PLANNING BOARD AGENDA

Meeting Date: Thursday, July 14, 2022

Subject: Blue Line Aviation- Conditional Zoning Map Amendment
Department: Planning
Presented by: Mark Helmer, Senior Planner
Presentation: Public Hearing

BLUE LINE AVIATION SCHOOL REZONING PUD APPLICATION SWIFT CREEK ROAD 3149B SMITHFIELD, JOHNSTON COUNTY, NC, 27577

OVERALL SITE PLAN

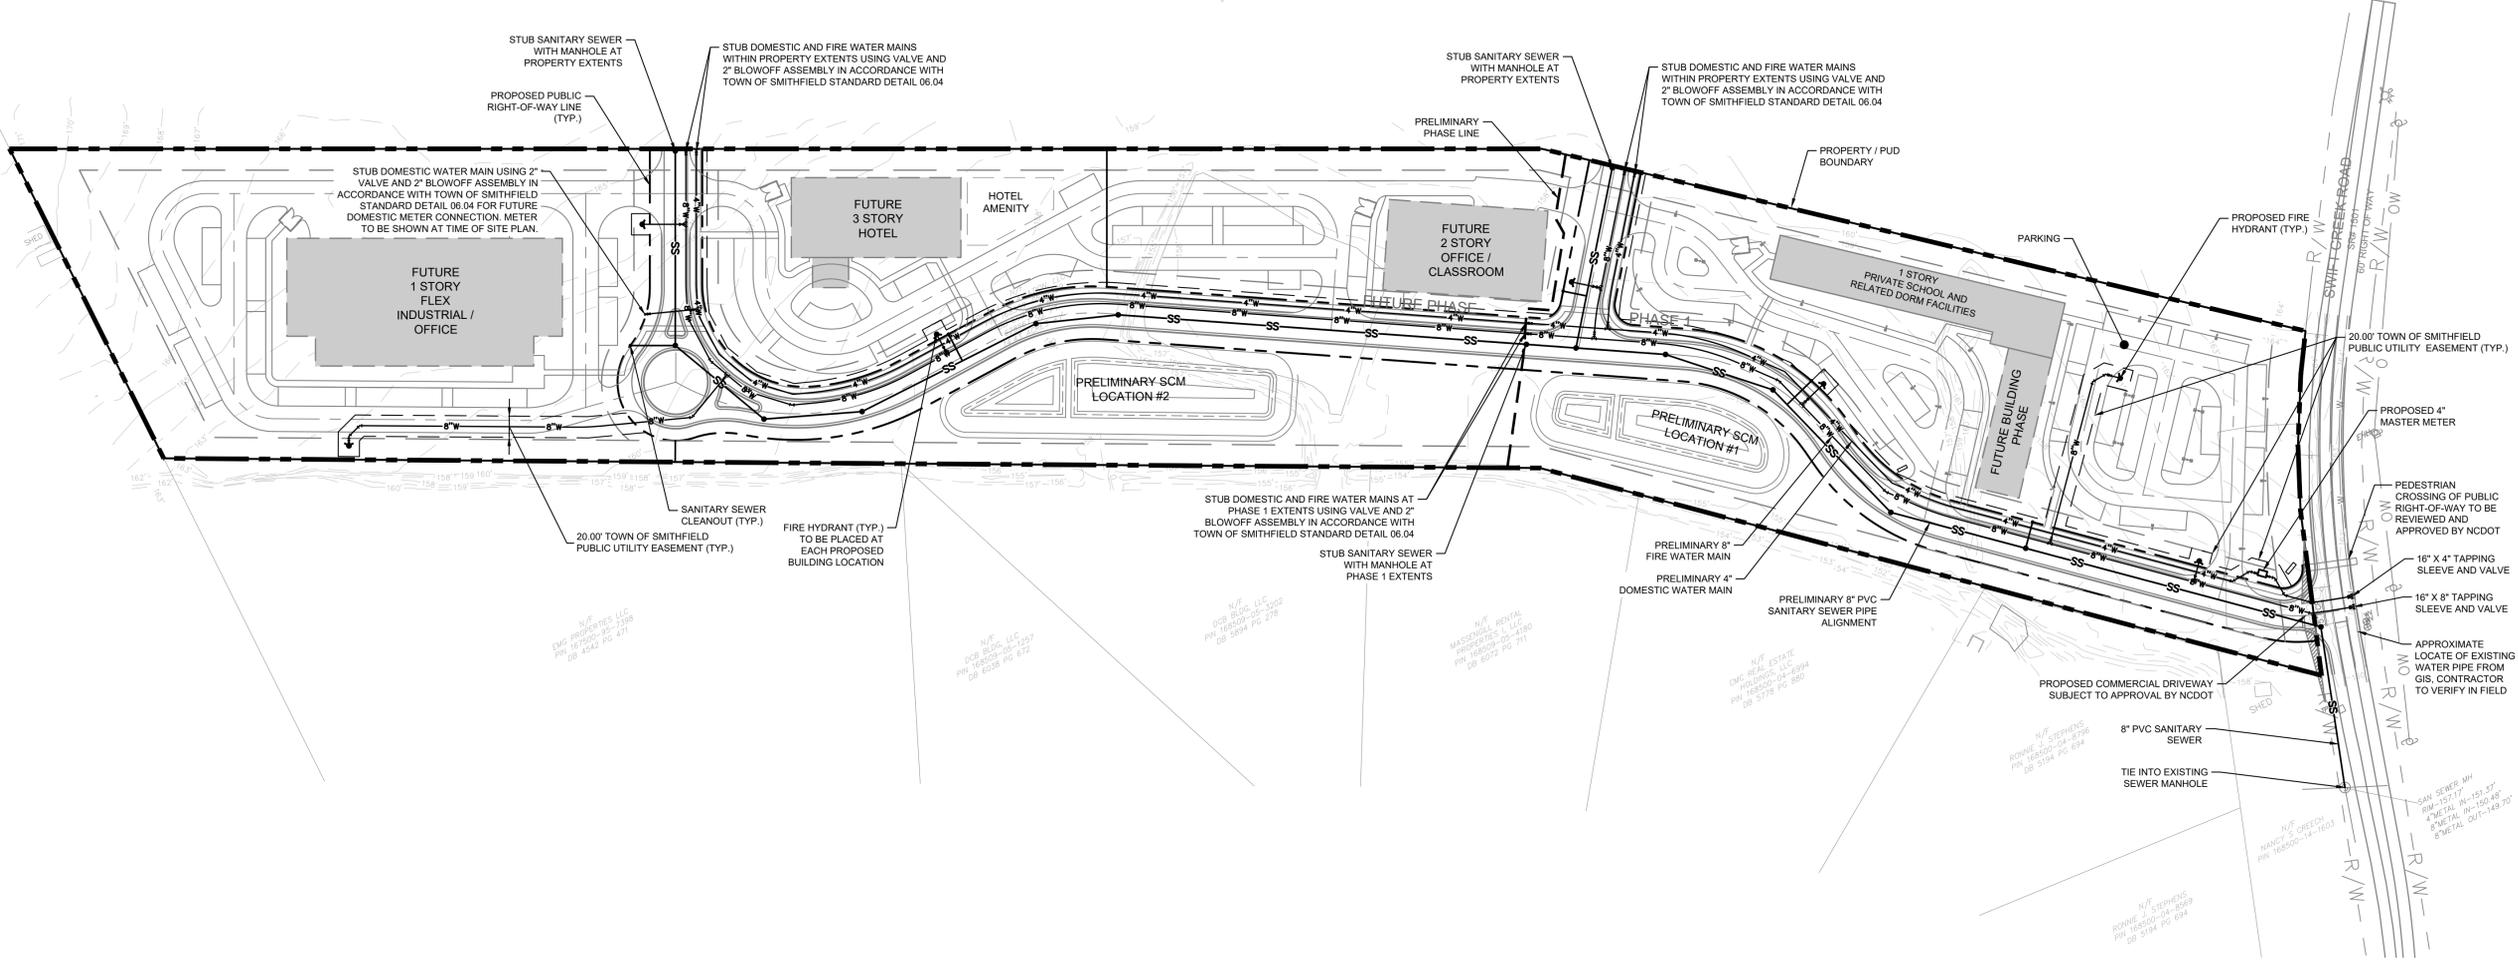
- The dorm facility in phase 1 is shown to have a 26' rear setback
 - The future hotel in the future phase is shown to have a 28' rear setback
 - The setback from Swift Creek Road is 50', not 30' as shown on the plan.

- Foundation plantings and interior parking lot island shrubs are not shown.
- **Parking.** The master plan shows 138 parking stalls in phase 1 and 154 in future phases. Based on the all the uses and building areas there is a total parking deficit of approximately 57 spaces. The site is not well suited to shared parking so when each use is considered on its own, there is inadequate parking for the uses and building areas shown:

- In phase 1, there are 52 dorm units and 2 beds per unit. If each student has their own vehicle, 104 parking spaces are need. The master plan shows 138 parking spaces between the two parking lots. That leaves an excess of roughly 34 spaces as overflow for the Blueline facility on the airport property.

- The future 3-story hotel is described as having +/- 120 rooms. The parking requirement would therefore be +/- 125 parking stalls (1 per room employees). The master plan shows approximately 50 parking stalls. The property is deficient approximately 75 parking stalls.

- The flex industrial property requires 1 parking stall per employee for industrial, but 4 spaces/1000 sq. ft. for office. The Master Plan shows 65 parking spaces which may be in excess of what is needed depending on how the building is used.

PRELIMINARY PHASE 1 LANDSCAPE PLAN

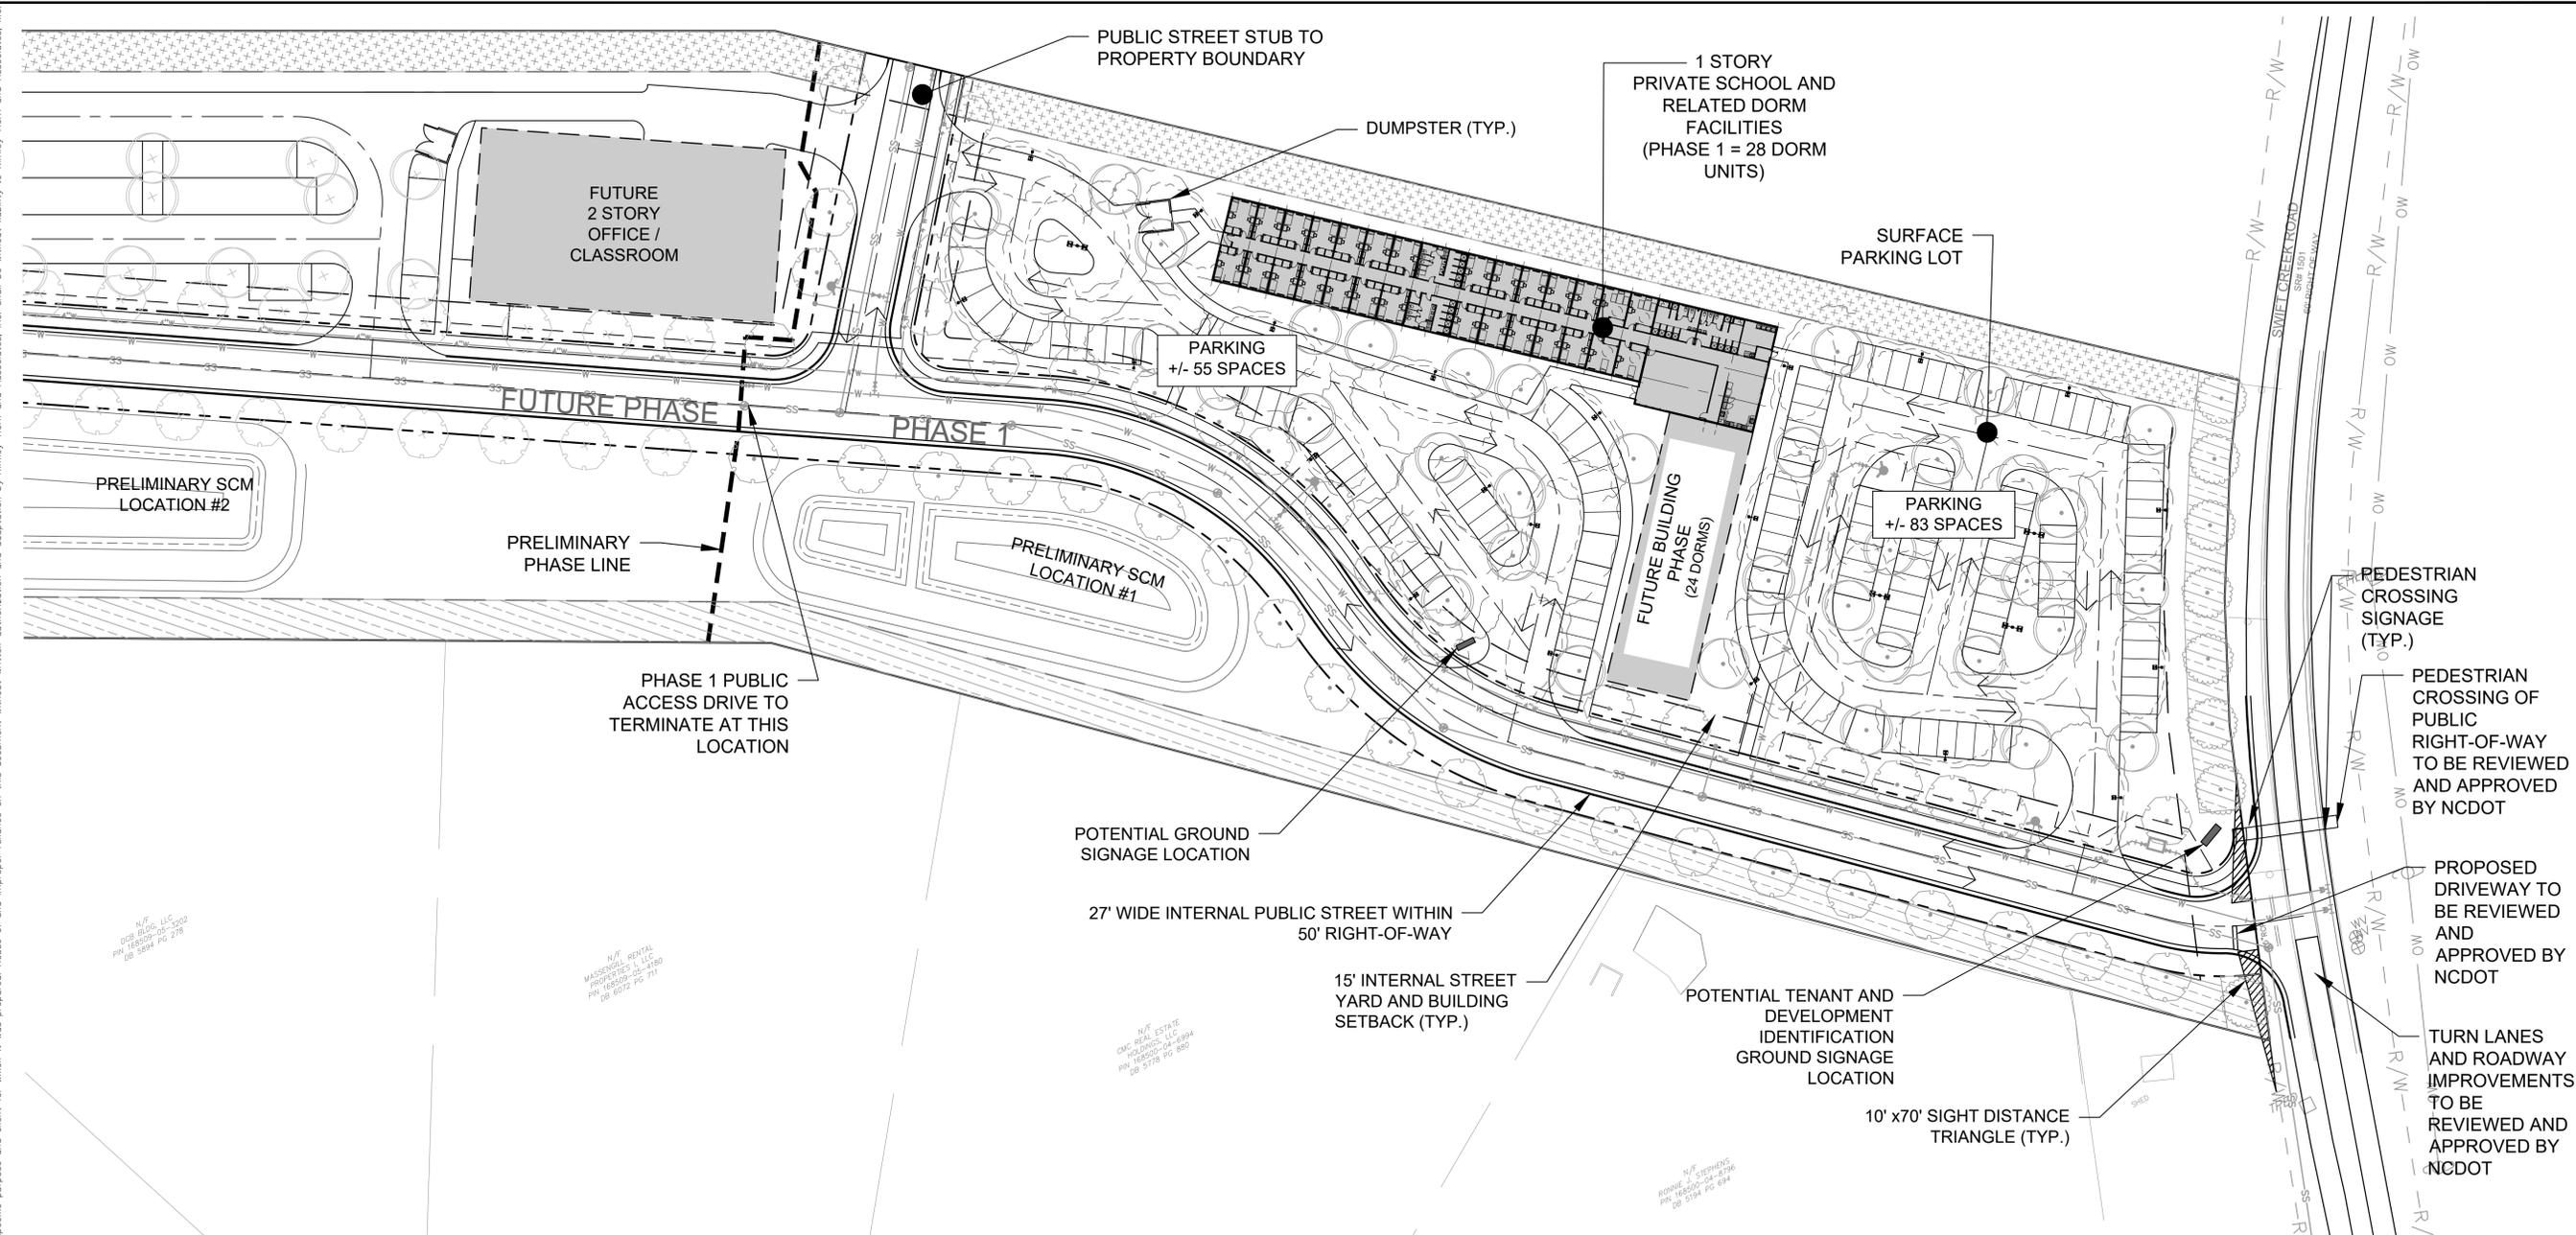
- **Landscaping and Buffering.**
 - The Master Plan shows trees in the street yard and parking islands and identifies the street and buffer yards. There are no details on shrub plantings.

- The buffer yard for the flex industrial/office should have a Type C planting, not a Type A.
 - The rear loading area of the flex industrial/office should be screened from the residentially zoned property to the north with an opaque fence, wall or solid vegetated buffer.

2. That the landscape plan be provided meeting the minimum requirements of the UDO Part III.
3. A 5' wide public sidewalk shall be provided along the Swift Creek right-of-way.
